## ADDENDUM NO. 2

**DATE:** October 8, 2019  
10/08/19

**PROJECT NO:** 190121

**RE:** AE Gage Center – Building A  
ADD-2, REV #2

**SHEET NUMBER**  
**A-102**

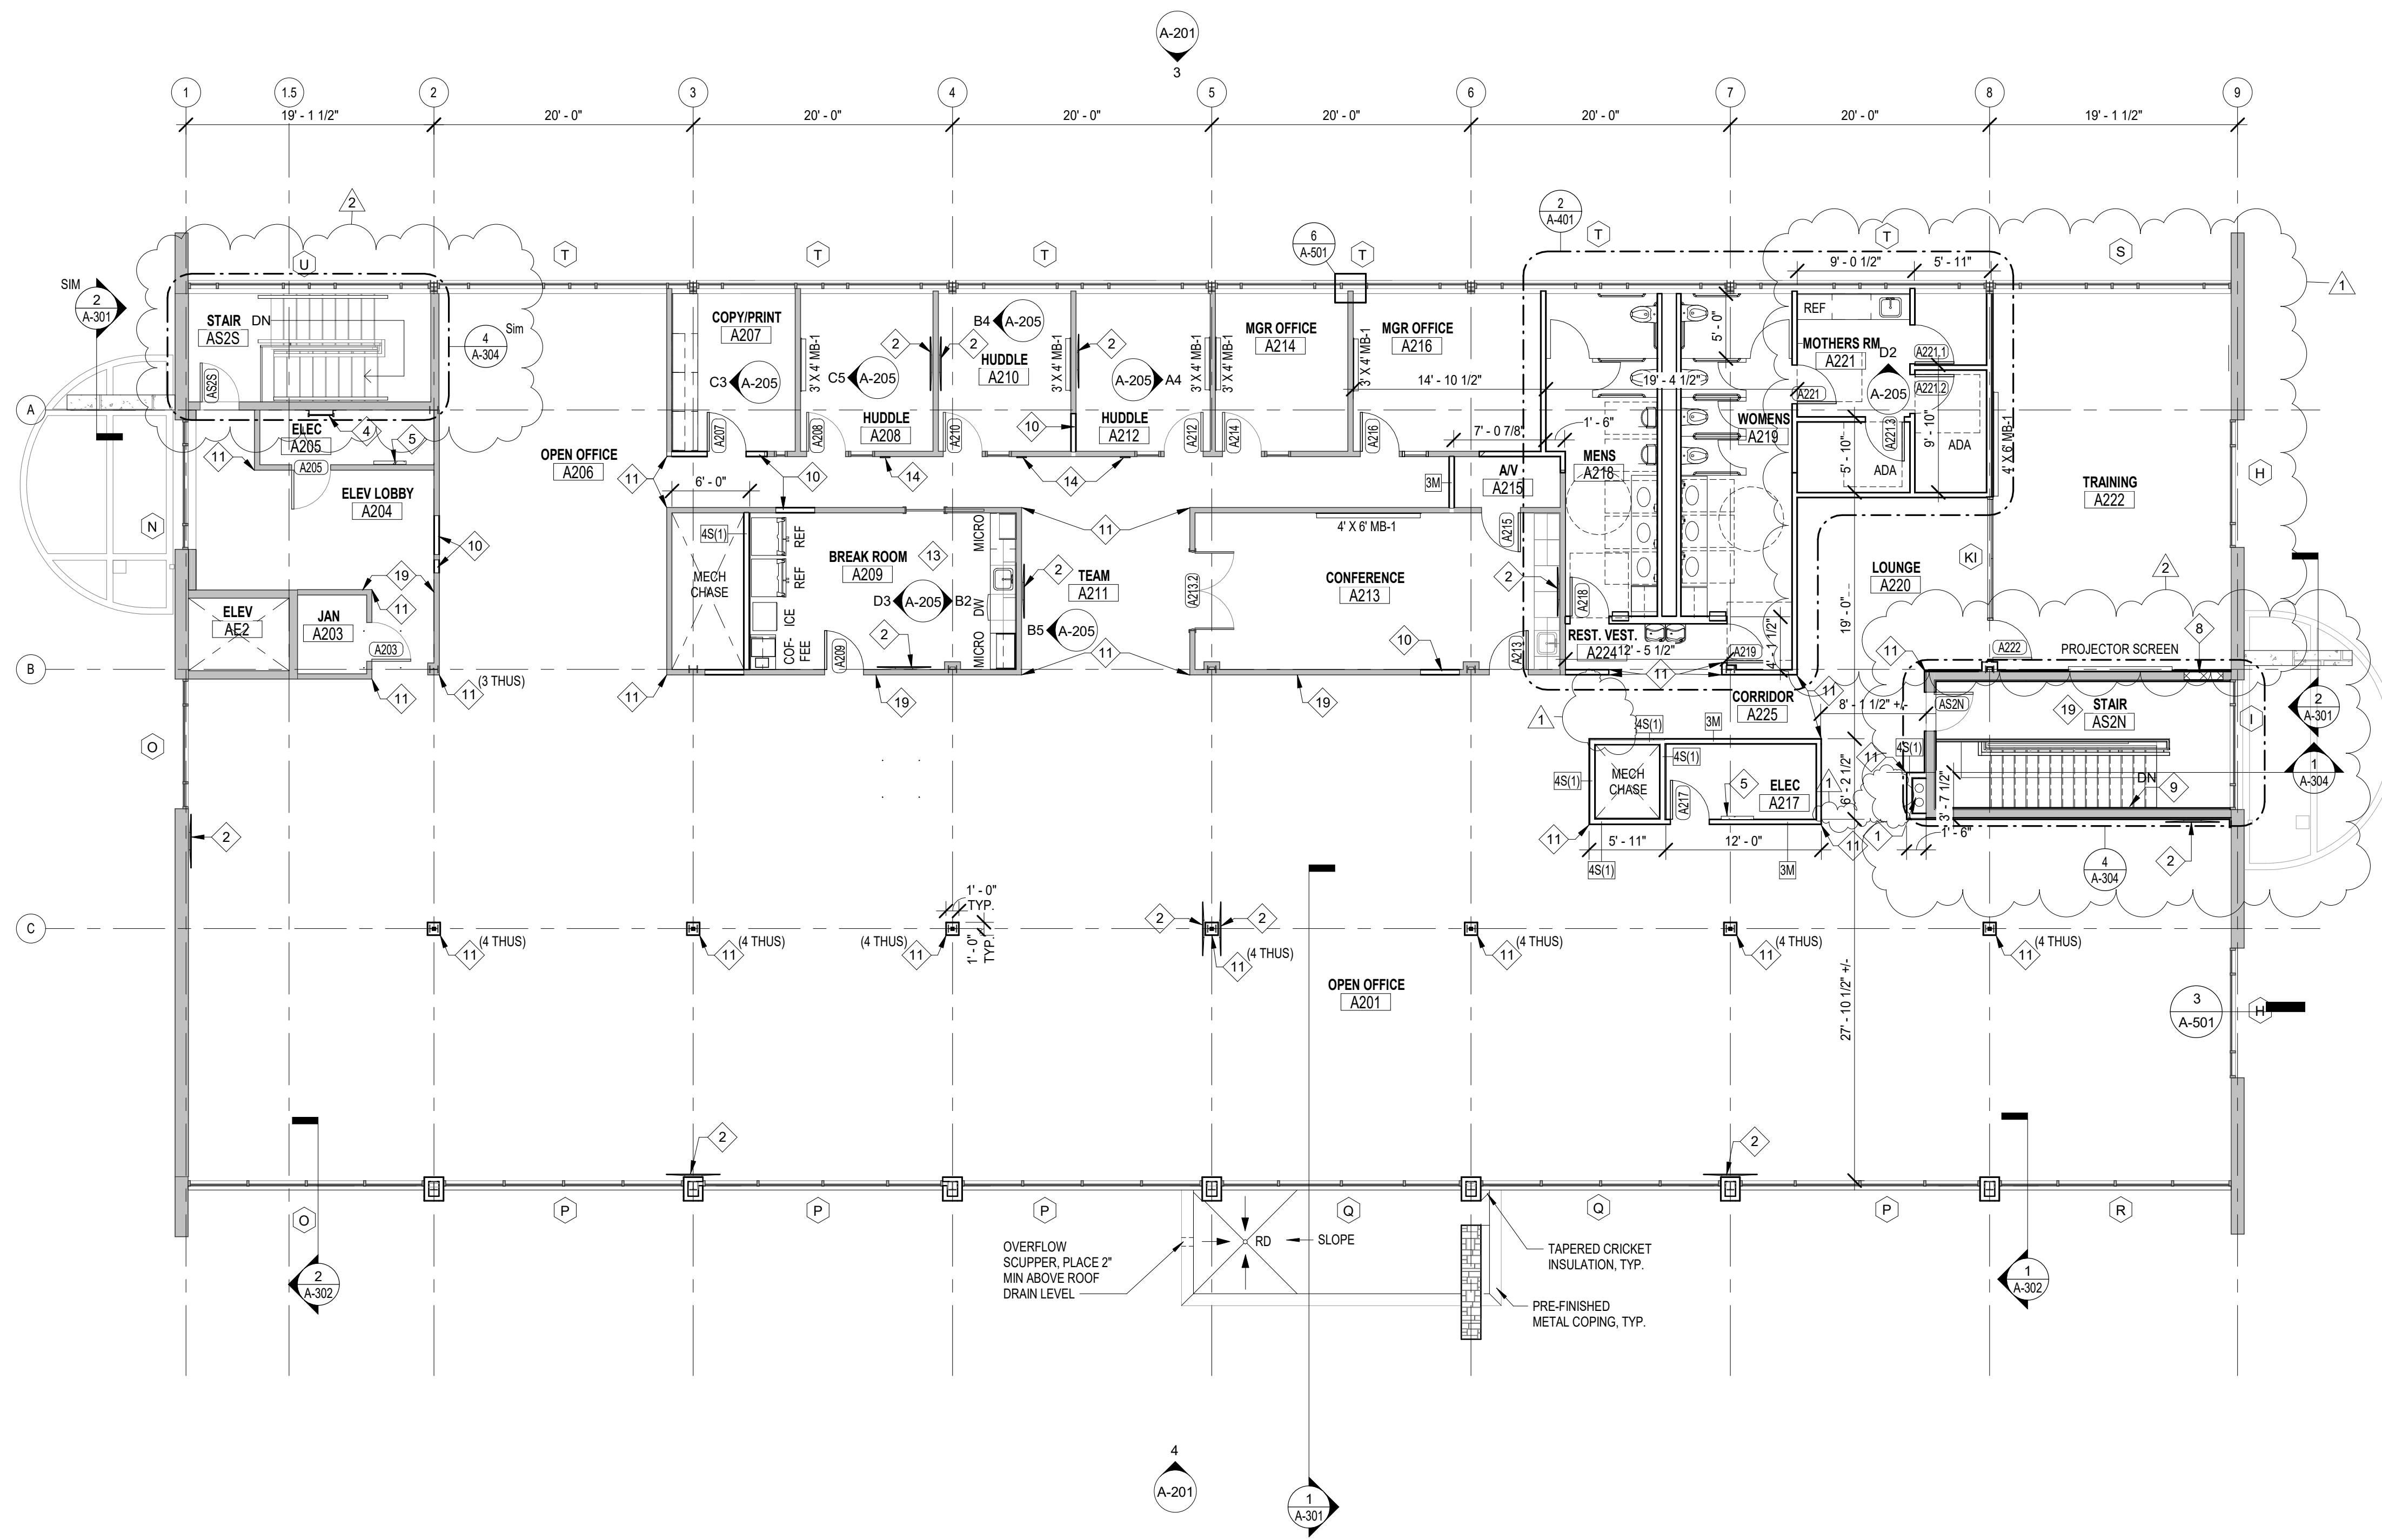
- A-3.A Add section mark 1/A304 and callout 4/A-304 at North Stair.
  - A-3.B The South stair shall be marked as similar to the North stair. The South stair will need a similar handrail and/or guardrail as the North stair. The GWB finish is not required, paint existing CMU.

**SHEET NUMBER**  
**A-112**

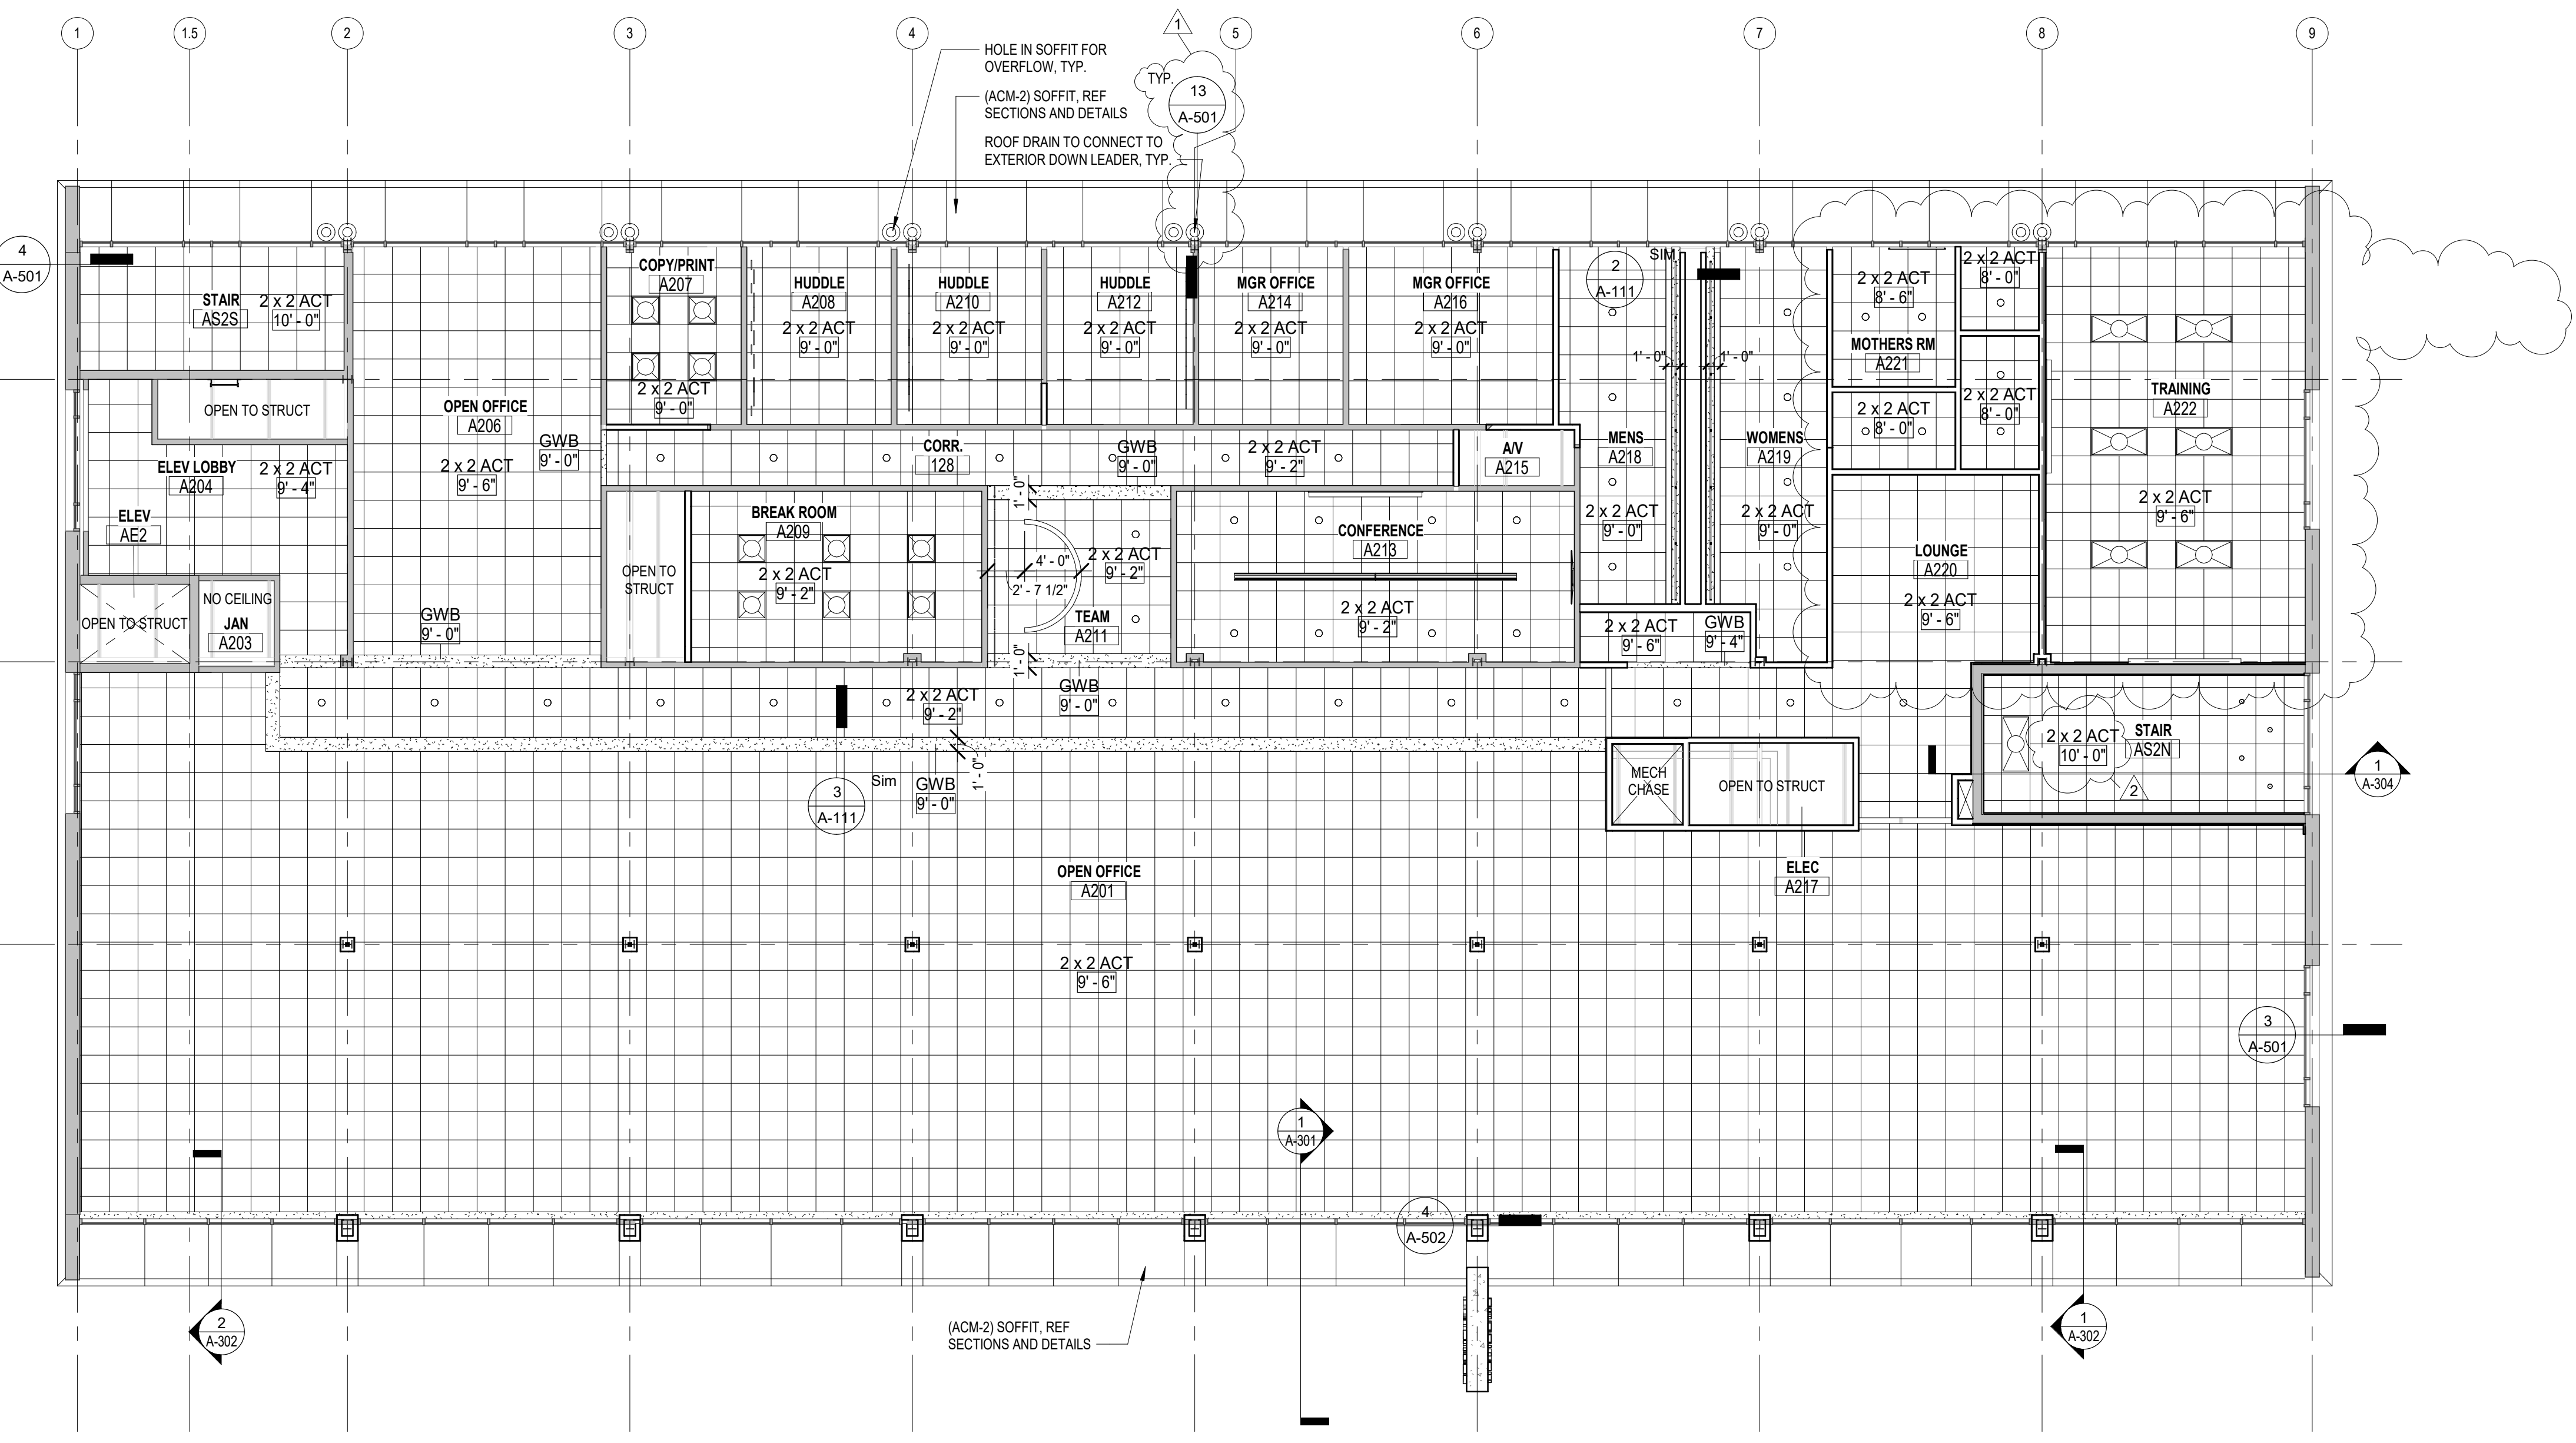
- A-4 Sheet A-112 – REFLECTED CEILING PLAN – BUILDING A – SECOND FLOOR: Revise ceiling height in Stairs AS2N to 10'-0"
- A-5 Sheet A-205 – INTERIOR ELEVATIONS AND MILLWORK DETAILS – BUILDING A: Stone tile to wrap corner as shown, ref detail.

**C1 SECT. @ RECEPTION DESK**  
SCALE: 1 1/2" = 1'-0"

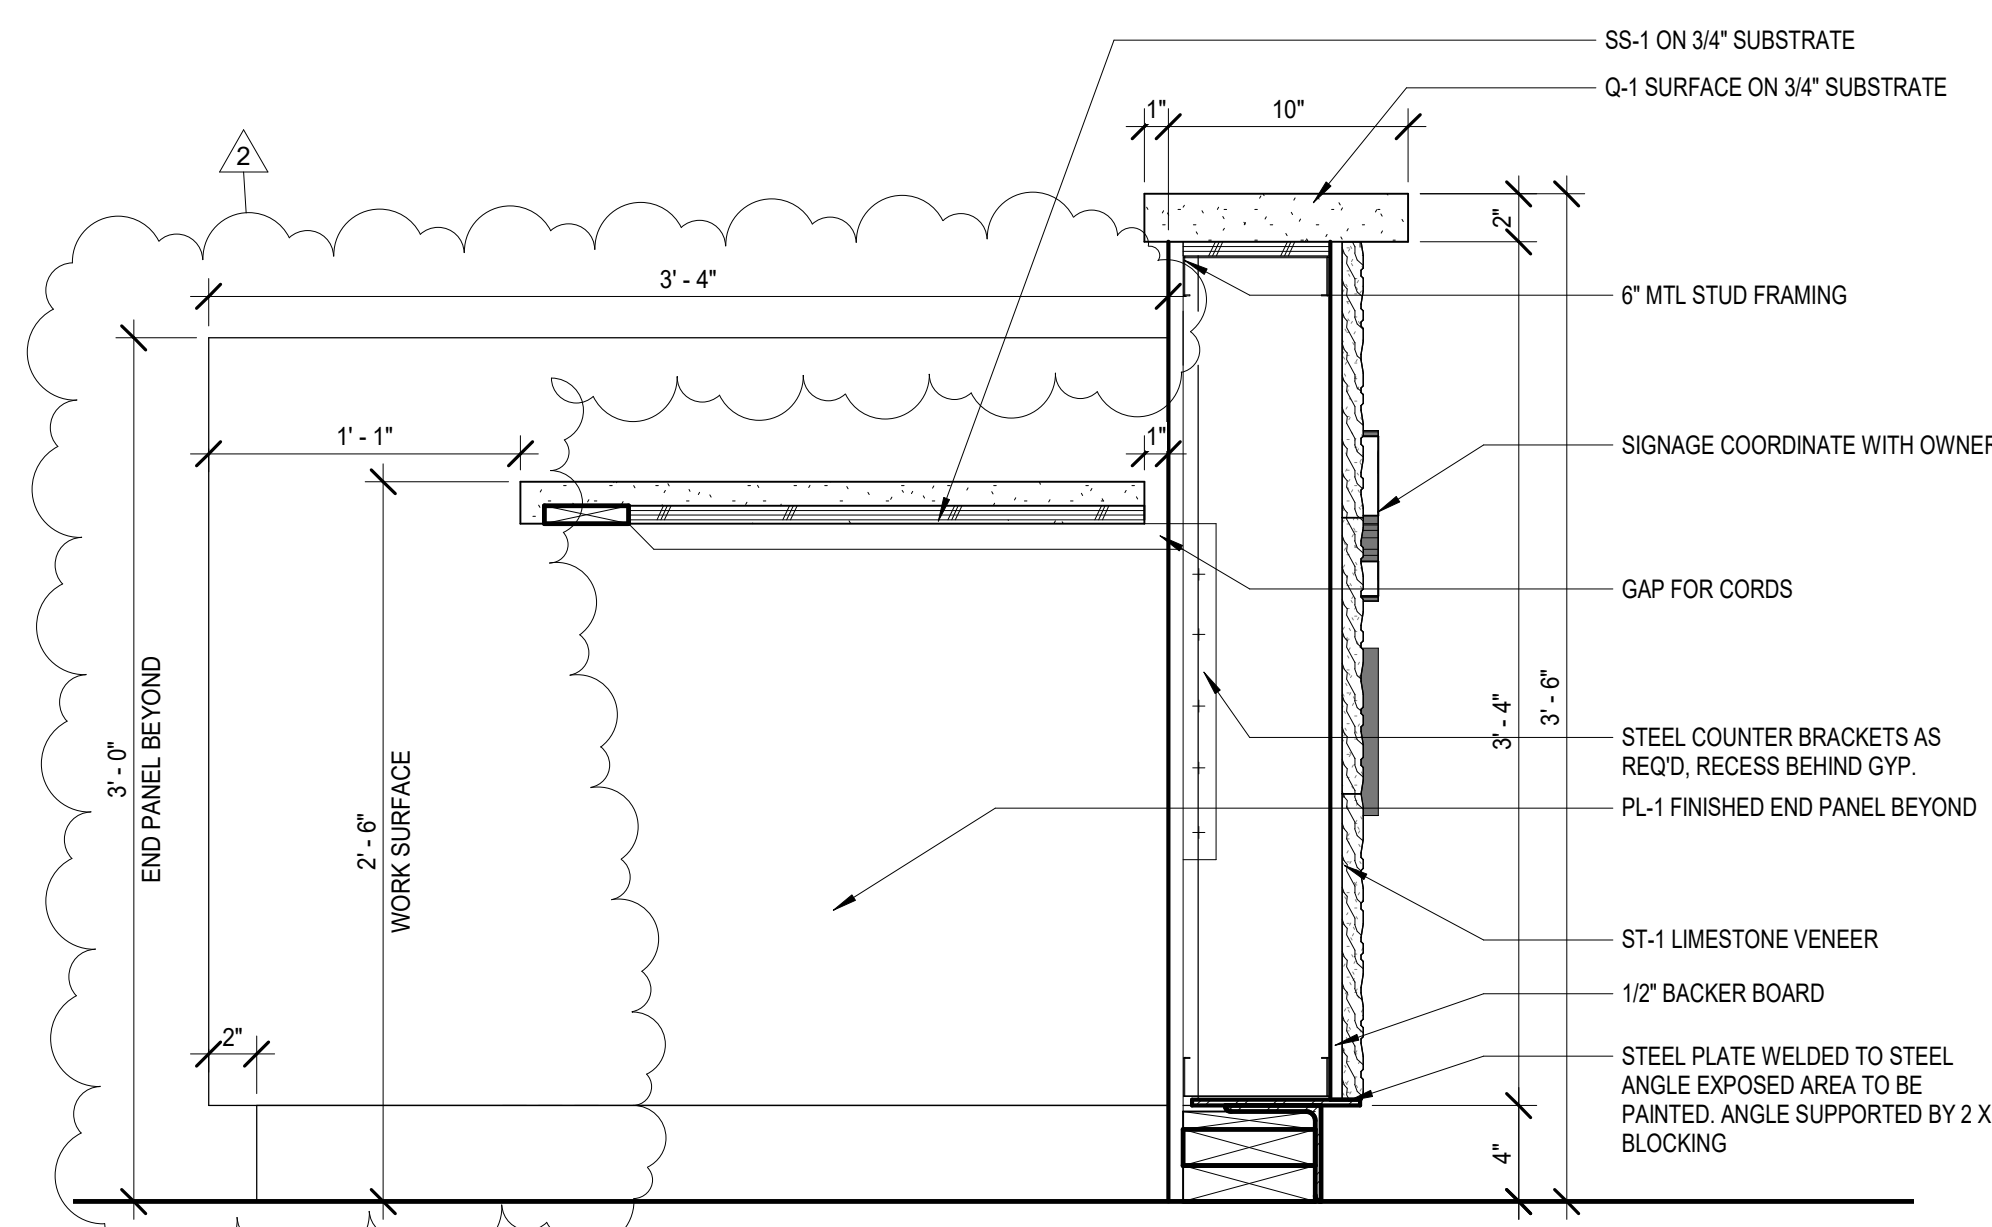
- A-6 Sheet A-206 – MILLWORK DETAILS:
  - A-6.A Detail C1/A-206 – Section at Reception Desk – Revised desk end panel dimensions to 3’-0” tall and 3’-4” wide.
